# Marion County Board of County Commissioners

# PLANNING & ZONING SECTION STAFF REPORT

Hearing Dates	P&ZC Date: 11/24/2025	BCC Date: 12/16/25			
Case Number	251209ZP				
CDP-AR	33384				
Type of Case	Rezoning: from General Agricu to Planned Unit Development (				
Owner	Linda Capozzoli				
Applicant/Agent(s)	Mastroserio Engineering, Inc.				
Street Address / Site Location	7317 SW 80TH ST				
Parcel Number	35460-039-00				
Property Size	±19.75 acres				
Future Land Use	Low Residential (LR)				
Zoning Classification	General Agriculture (A-1)				
Overlay Zone/Scenic Area	Urban Growth Boundary (UGB) Protection Overlay Zone (SSP)				
Staff Recommendation	APPROVAL WITH CONDITION	NS			
P&ZC Recommendation	TBD				
Project Planner	Erik Kramer, Planner				
Historic/Related Case(s)	Concurrent 25-S15 – Small-s map amendment from Low Re Residential (MR)	•

Figure 11
Front Setback Variation Typicals

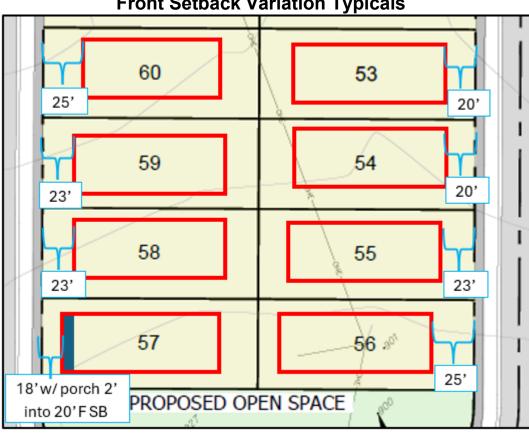
Analysis: Staff find the PUD proposes its own setbacks and height limitations on the PUD plan sheet. Table 3 of this report shows the proposed setbacks and height limits. The proposed minimum lot size and minimum side and rear setbacks are lower than typical Single-Family Dwelling (R-1) zoning for detached single-family development and lower than the A-1 zoning present in the surrounding. The proposed single-family uses are compatible with existing uses in the area; however, the proposed lot sizes and minimum yard sizes differ from the character of the surrounding area. The existing character is small farms and residential estates on larger lots to the north, east, and south with mature tree canopies. To the west is Hibiscus Park Unit 1 and 2, which were platted with smaller lots; however, the existing parcel configurations are large lots with mature vegetation on most of the lots. To match and enhance the character of the area, staff recommends the following conditions pertaining to shade trees and front setback variation (setback typical example shown in Figure 11):

- Each residential lot shall provide a minimum of two (2) shade trees. The shade trees shall be a minimum of four (4) inch caliper at the time of planting.
  - On the side of the street where internal sidewalks are provided, every other lot must locate one (1) of the required shade trees within the front yard and within ten (10) feet of the sidewalk edge.
- With any group of three (3) consecutive dwelling units along the same street frontage, the front building line of each dwelling shall vary by at least two (2) feet and no more than five (5) feet from the adjacent unit. No more than two (2) consecutive dwellings may have the same front setback. The pattern of setback variation shall be shown on the improvement plan during development review and maintained through building permit review.

- 8. With any group of three (3) consecutive dwelling units along the same street frontage, the front building line of each dwelling shall vary by at least two (2) feet and no more than five (5) feet from the adjacent unit. No more than two (2) consecutive dwellings may have the same front setback. The pattern of setback variation shall be shown on the improvement plan during development review and maintained through building permit review.
